Re: Arlington Storage Company, LLC, Seneca Lake Storage Facility Gallery 2 Expansion Project, Docket CP13-83, Expert Geologist Report

January 15, 2014

FIGURE 2 PROFILE OF WATKINS GLEN
BRINE WELLS NOS. 27, 28, & 30

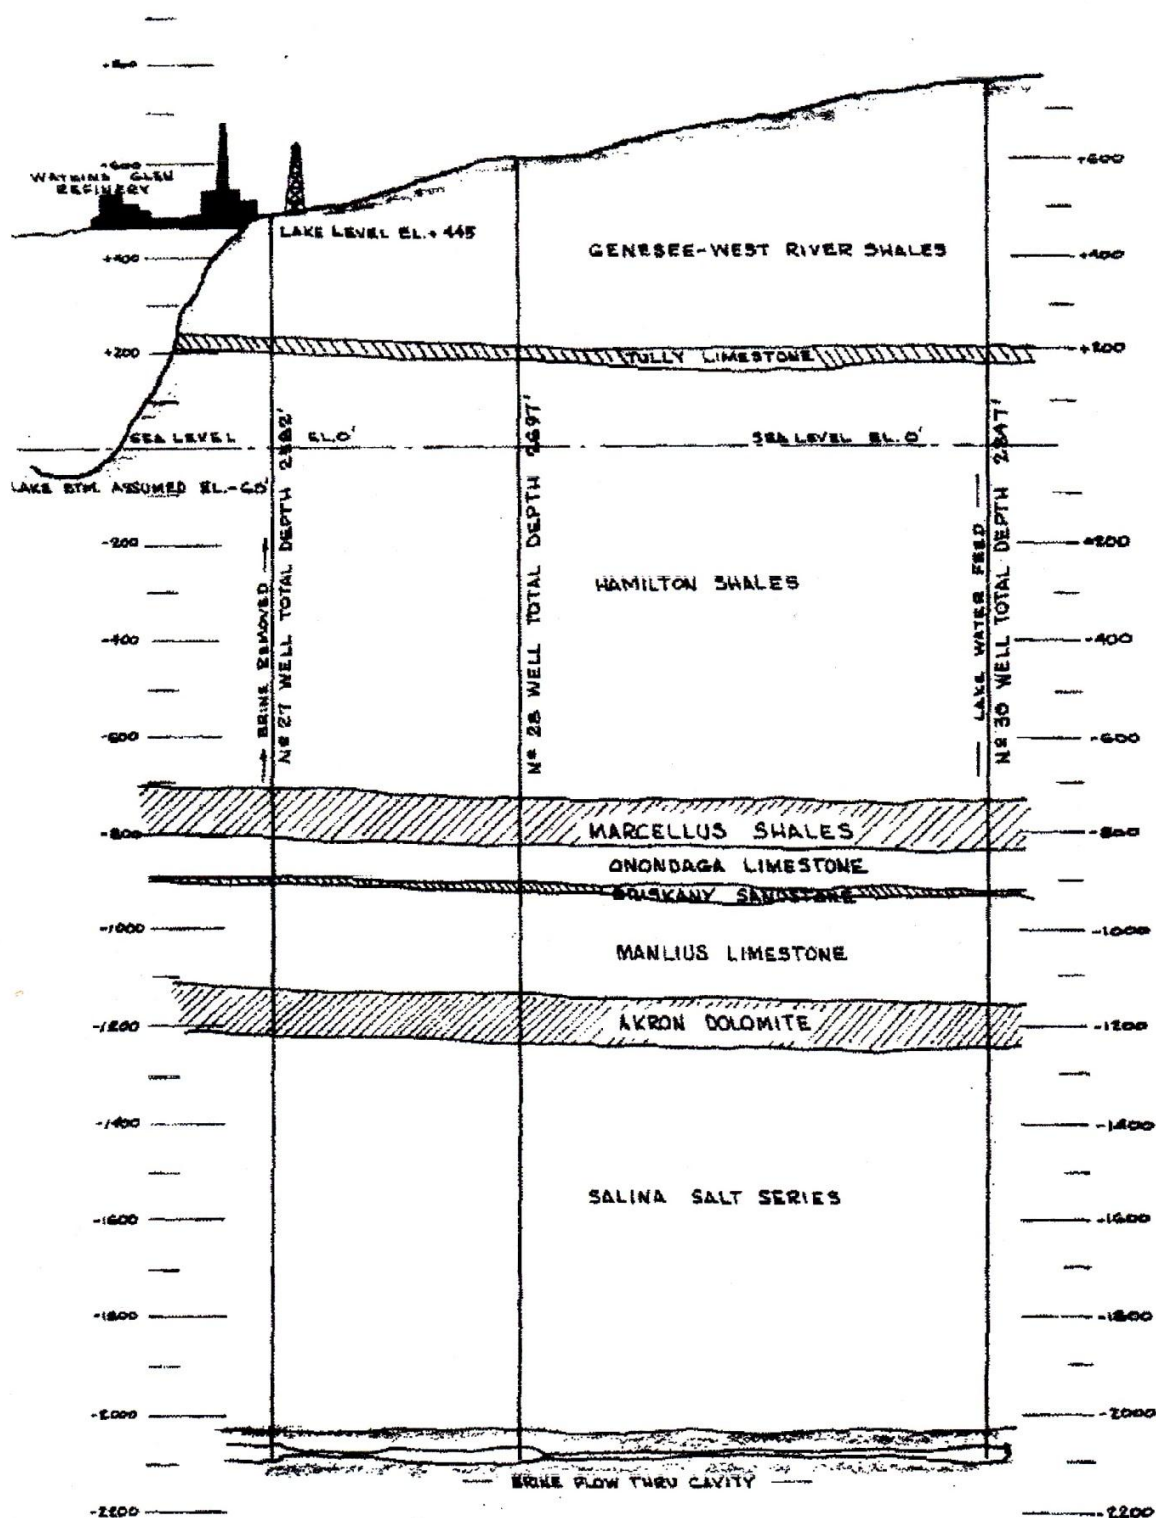
The next cross-section from the Jacoby 1969 paper (his Figure 2, attached as Exhibit 3) shows the situation in June of 1964. Initially, Well 30 and Well 31 were both hydraulically fractured at the lower B2 salt layer, but the process failed to connect the two wells by way of the lower B2 salt (see near-well fracture at wellbore depicted at the lower B2 of Well 31). “The connection between the two wells was finally completed in the **fault zone in the overthrust block** of B2 salt.” (Jacoby, 1969) (emphasis added). Jacoby wrote extensively about using an understanding of this thrust fault geology to design hydraulic fracture programs and to take advantage of a weakened fault zone path to a target well. And with regard to these wells, he notes: “At the points on the cross-section where faulting has been confirmed, fault zones several feet in thickness are present.” (Jacoby, 1969) Following fracturing, communication was established between Wells 30 and 31 and Gallery 2 solutioning development began. The cross-section of Jacoby’s Figure 2 shows that the two connected caverns were being used for LPG

storage in 1964 as shown by the propane legend symbol in the upper part of Cavern 31 and at the top of Cavern 30. The vertical extent of the hydraulically fractured fault zone connecting Cavern 30 to Cavern 31 is discussed only qualitatively in the paper, but the areal extent of the hydraulic fracture connection must be significant since publicly available mapping⁵ shows Well 45 to be offset from a straight line connecting Wells 30 and 31, and it intercepts the fractured fault zone connection and will be used in the Arlington plan as a monitor well. While on the subject of the hydraulically fractured connection between Wells 30 and 31, there is a cross-section in another Jacoby paper that shows a connection between Well 30, Well 27, and Well 28 (Jacoby, 1961, Figure 2 attached as Exhibit 4). That paper is a discussion of the brine mining process and the wells are not discussed specifically. If there is or was a connection, that would connect Gallery 2 to Gallery 1, and this would be a significant concern. Arlington must have all the original records, and it could provide that information from the original source to resolve this question. The connection by way of a fault zone that affects both Well 30 and Well 31 and beyond, and perhaps way beyond, is not discussed in the public Arlington documents that I have reviewed.

Figure 3.

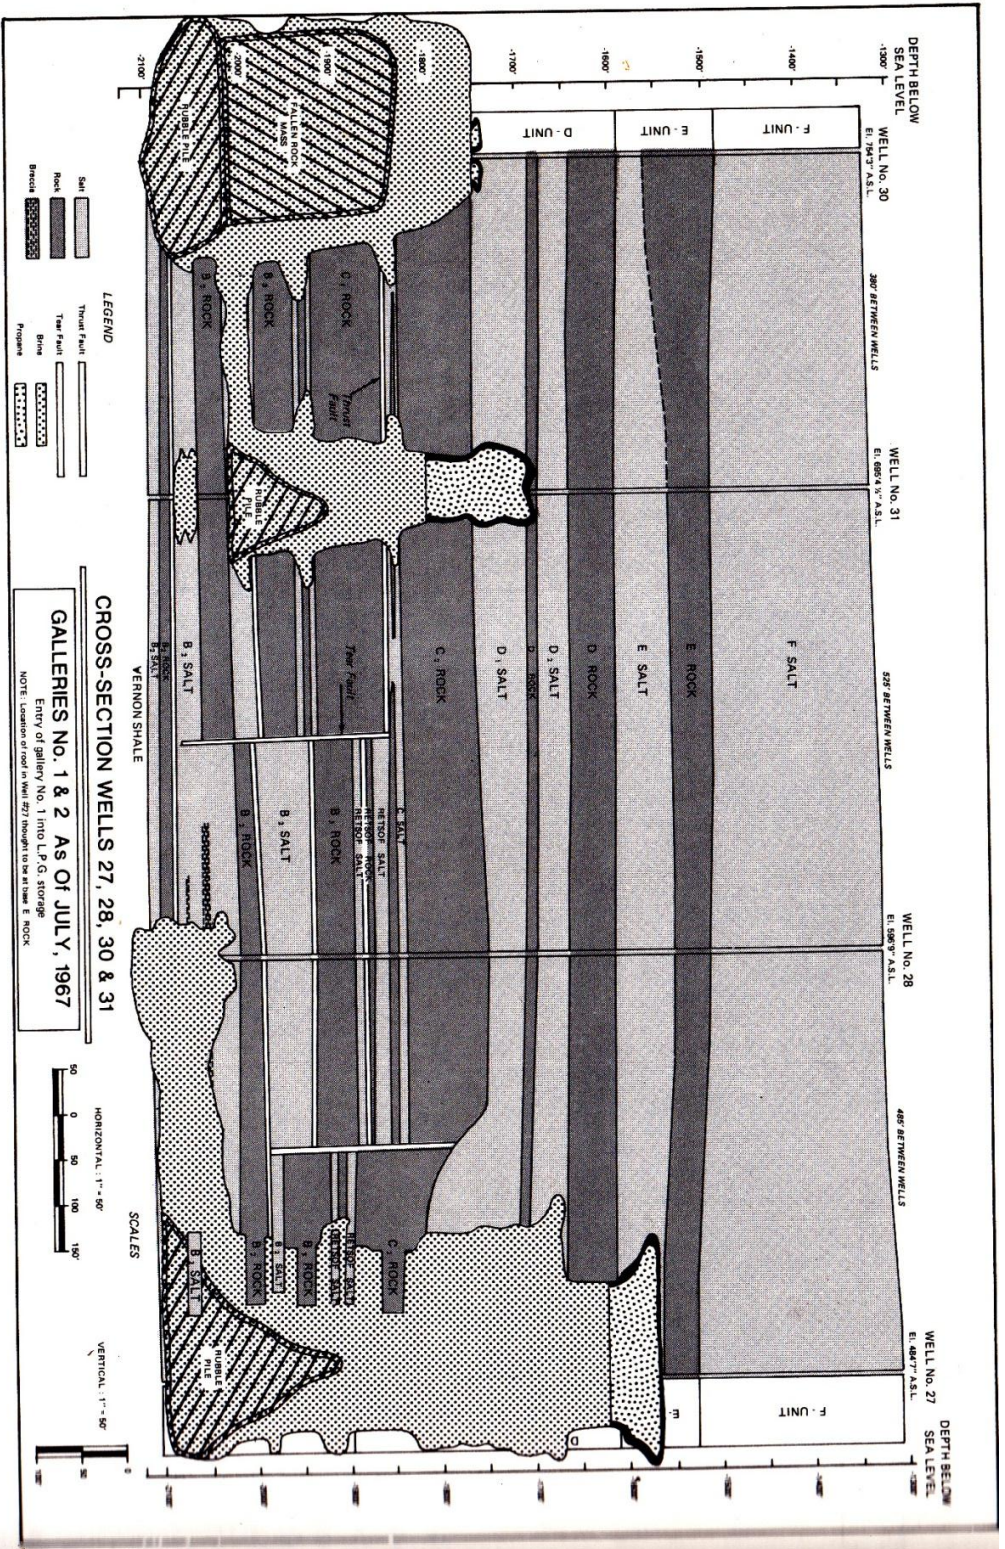
By July of 1967, the date of the next cross-section, both Gallery 2 (Cavern 30 connected to Cavern 31) and Gallery 1 (Cavern 27 connected to Cavern 28) were being used for LPG storage. (Jacoby Figure 3, attached as Exhibit 5). By this time, the caverns had expanded, leaching salt and accumulating rubble where interbedded unsupported rock layers had fallen. Jacoby depicts the four caverns filled with a combination of brine, propane, and rubble. In perhaps the most striking revelation of this review, there is a large intact block in Cavern 30 with a suspicious jig-saw puzzle fit to the cavern outline above and noted as “Fallen Rock Mass” on the cross-section. That is, Cavern 30’s roof failed, and the rock fall was dramatic. This is explained by Jacoby as a lesson to use saturated brine in cycling product out of the caverns:

Unless saturated brine is used continually in recycling the product, there is distinct possibility of undermining **fault blocks**. Illustrated in (Jacoby) Figure 3 is a large block of rock calculated to weigh over **400,000 tons** which **fell from the roof** even with the use of saturated brine.

(Jacoby, 1969) (emphasis added). Perhaps anticipating, even then, an attempt to discredit this cavern roof rock fall event, he went on to say: “This portion of the cavity was outlined by using sonar surveying equipment.” The parallel between the fault block cavern roof failure in Cavern 30 and the roof collapse in Cavern 58 is obvious. It is clear that researchers working on caverns in the Watkins Glen brine field have encountered cavern roof failures and attributed these failures to fault situations. It is essential that cavern roof failure in the Watkins Glen brine field be recognized.
